From: Littelfuse Product Management

Subject: Change of carrier tape thickness pocket for 1206 series fuses

PCN number : 19092016

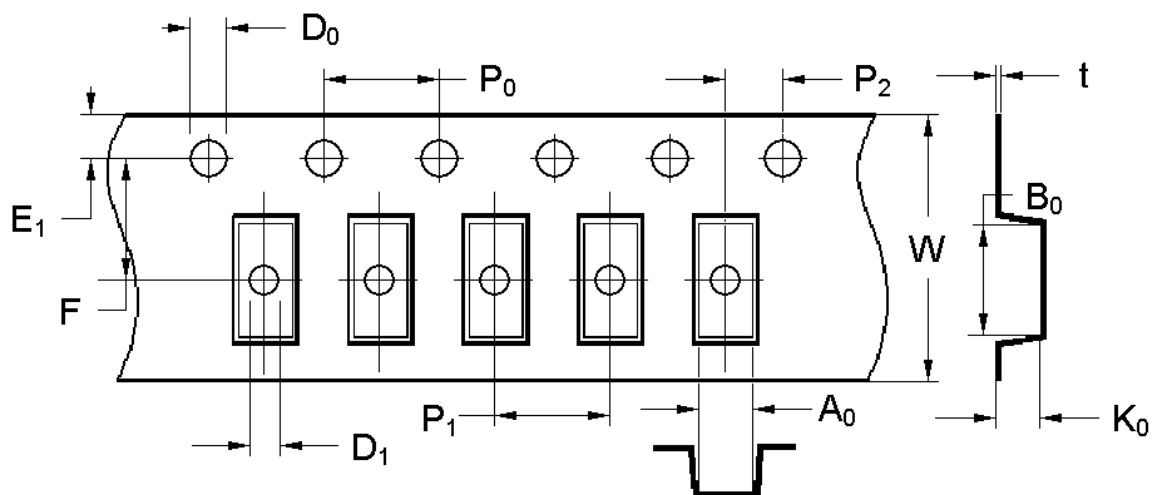
We are changing the tape size thickness of all our 1206 footprint fuses. Please see below on the tape thickness change. It impacts only the K0 dimension as shown in the below diagram.

<b>Before change</b> mm(inch)	<b>After change</b> mm(inch)
Tape size thickness: K0	1.27 ± 0.10 (0.050 ± 0.004)	1.10 ± 0.10 (0.043 ± 0.004)
